ADDENDUM #2

Date:	03.05.2014	Addendum No:	2
Project:	York General Health Care Services Hospital Addition And Remodel	Project No:	24902
To:	Jake Kulhanek	Firm:	Sampson

ALUMINUM
FRAME TYPES

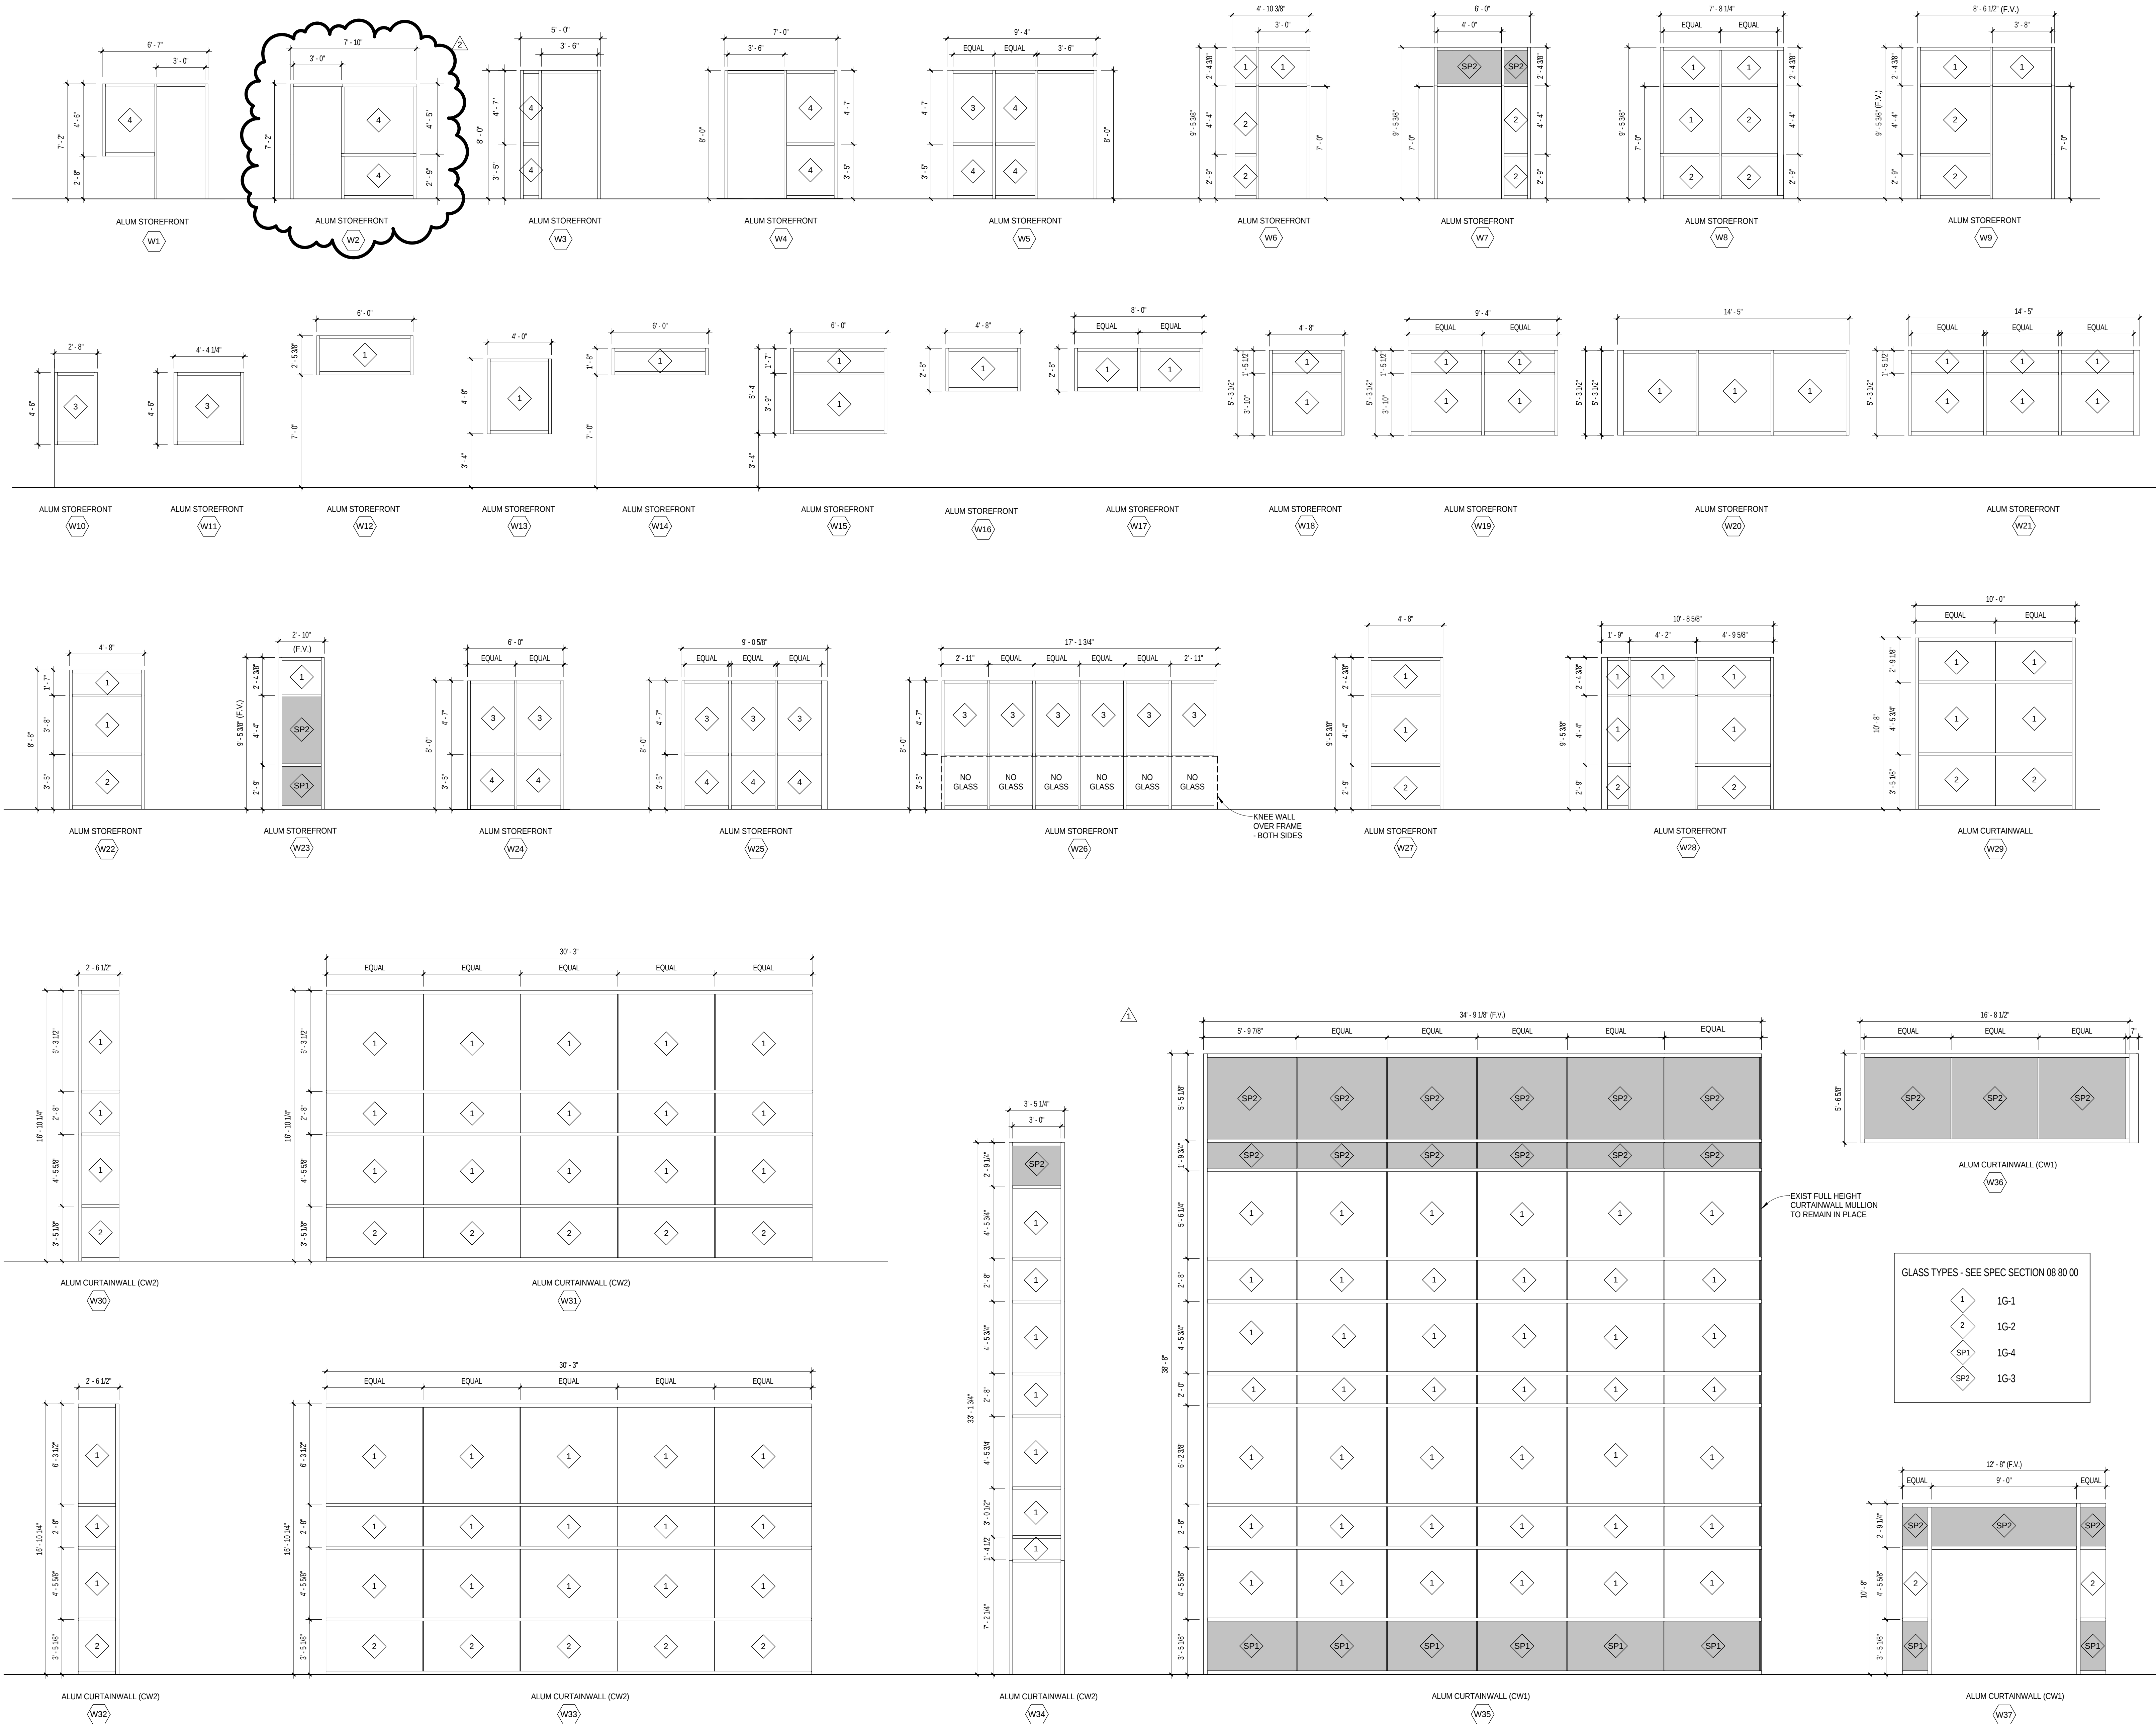
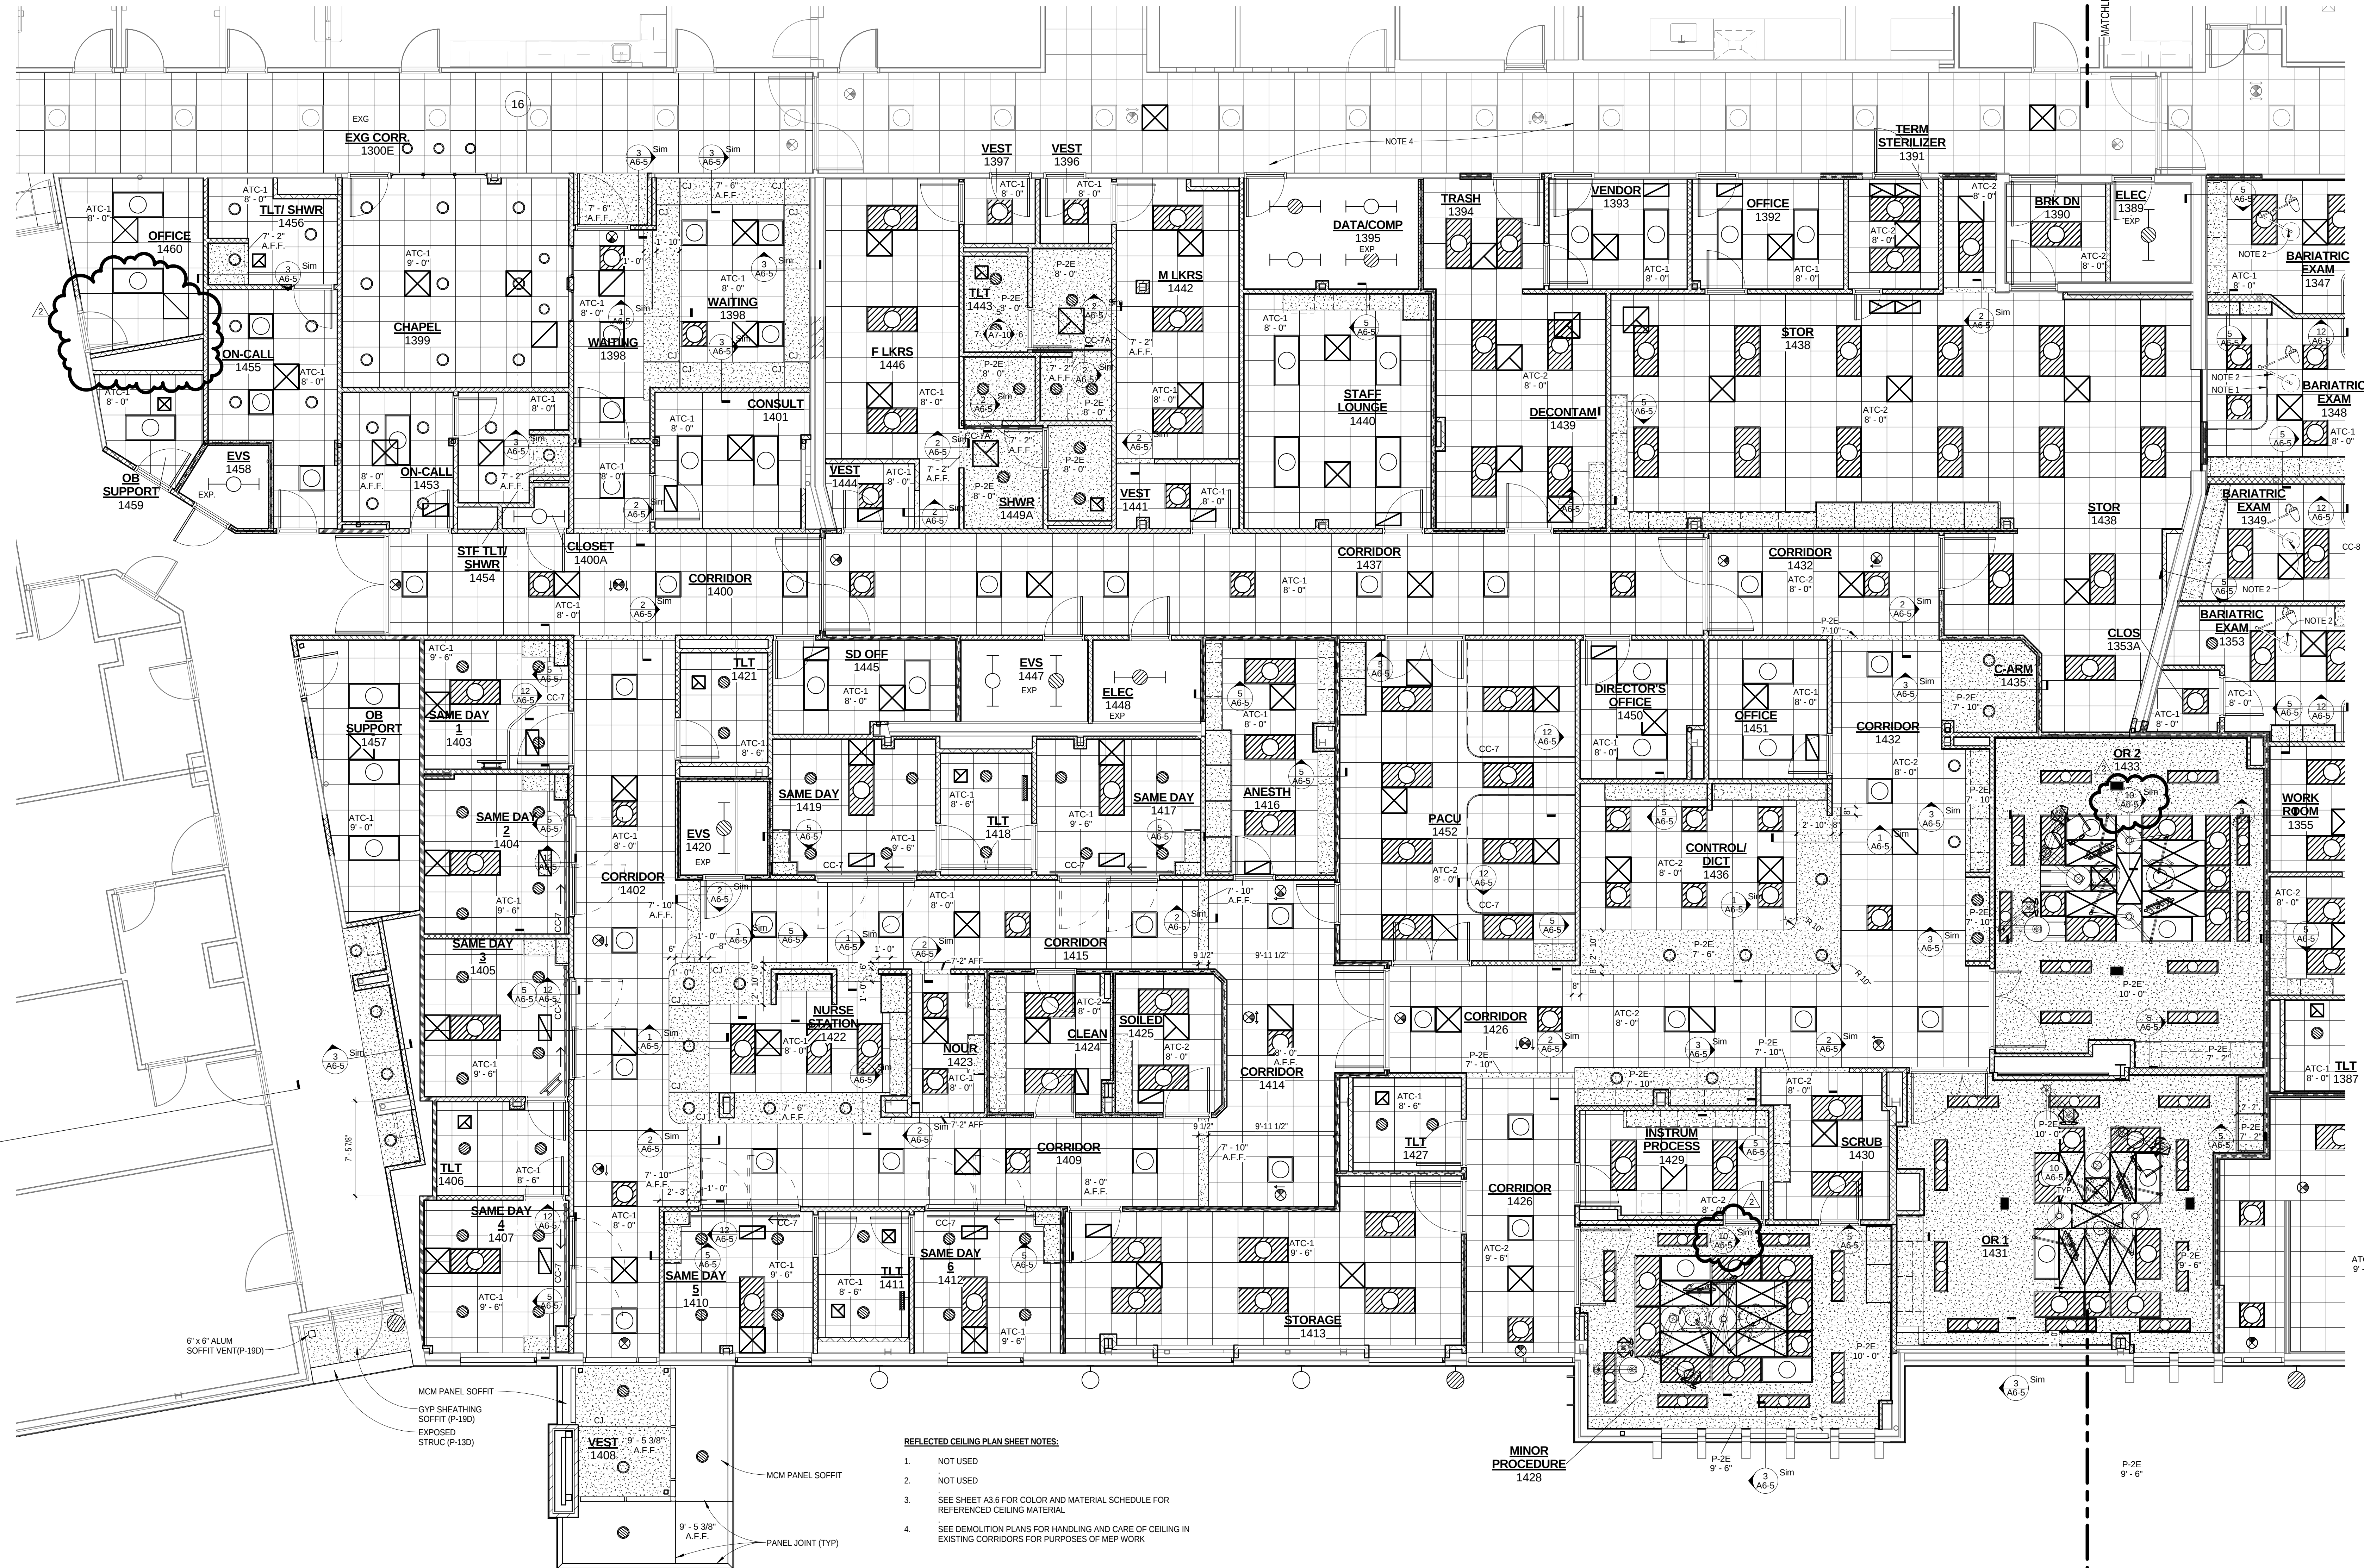
4. Sheet A3-1, ALUMINUM FRAME TYPES. (Reissue sheet in its entirety):
 - a. Modify type “W2”.
5. Sheet A3-1, COLOR AND MATERIAL SCHEDULE
 - a. Modify WB-2 to read as follows: “HUNTER DOUGLAS CONTRACT; MANUAL SINGLE SHADE RB 500 SERIES; SHEERWEAVE 2390, OYSTER BEIGE”.

1 FLOOR PLAN LEVEL 1 - LIGHTING - AREA "C"
E1-3 3/16" = 1'-0"

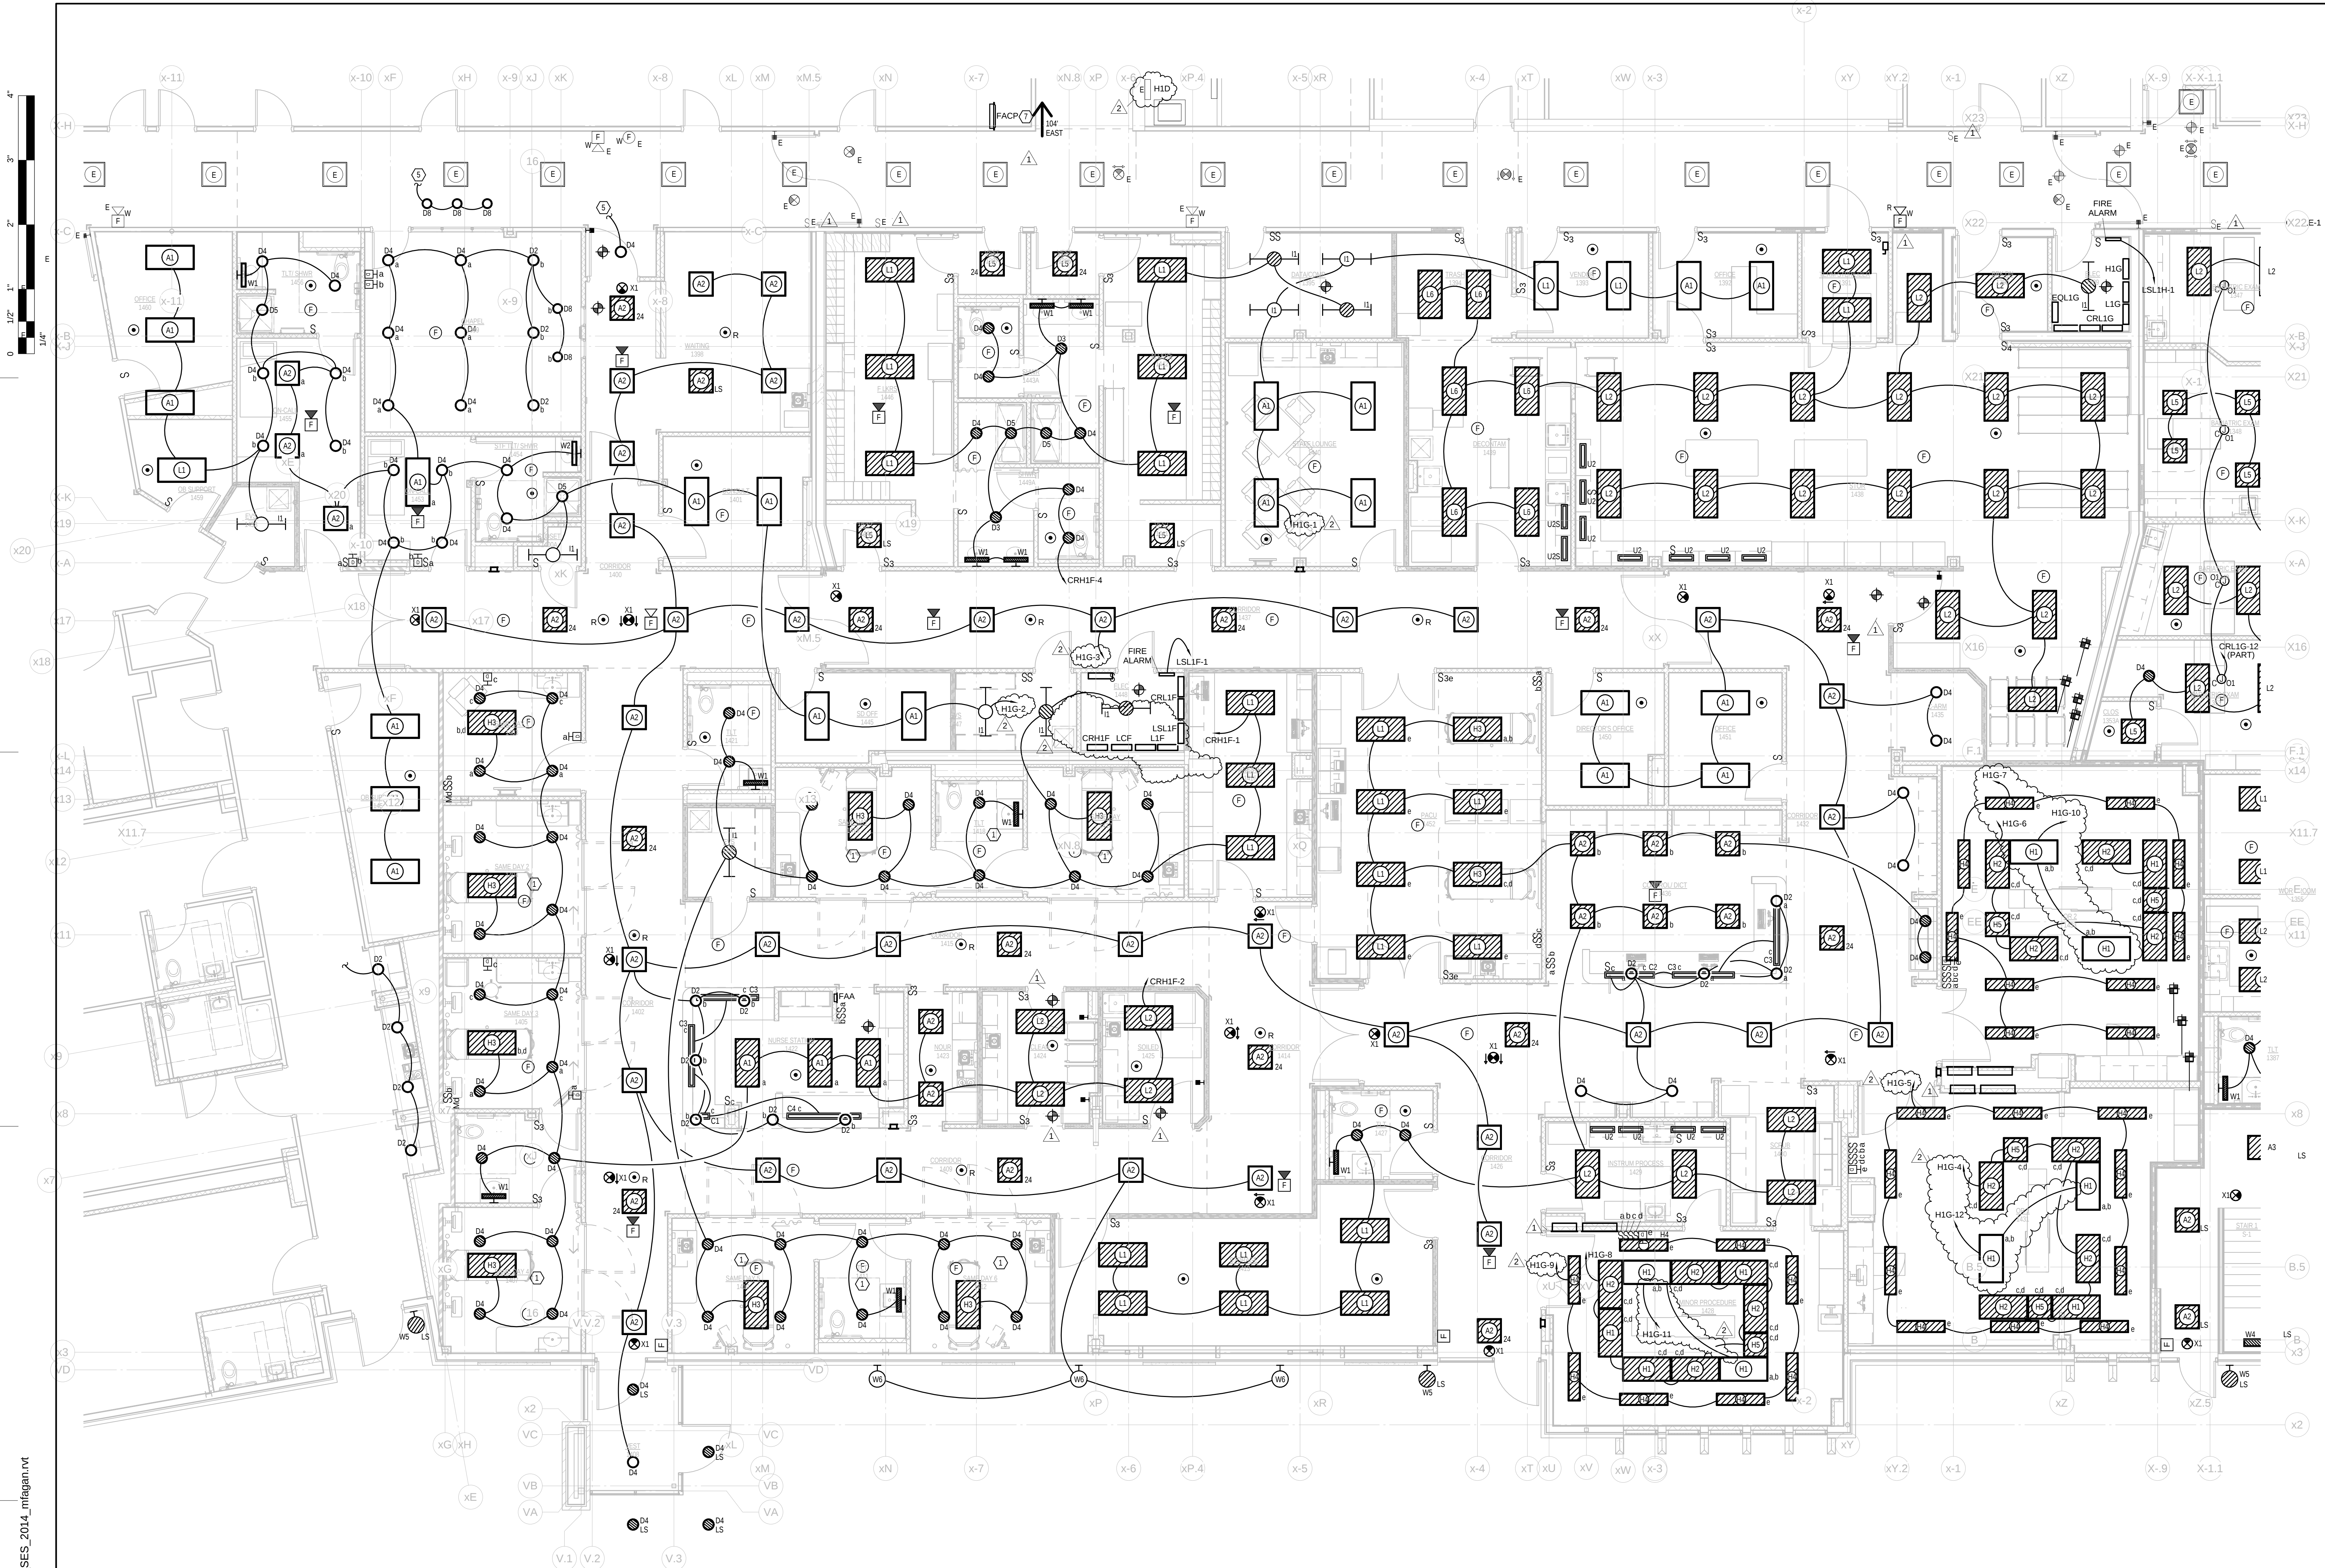
- A. E1-3 – Floor Plan – Lighting – Area C
- B. E2-3 – Floor Plan – Power – Area C
- C. E4-1 – Electrical One-Line Diagram
- D. E5-1 – Electrical Panel Schedules
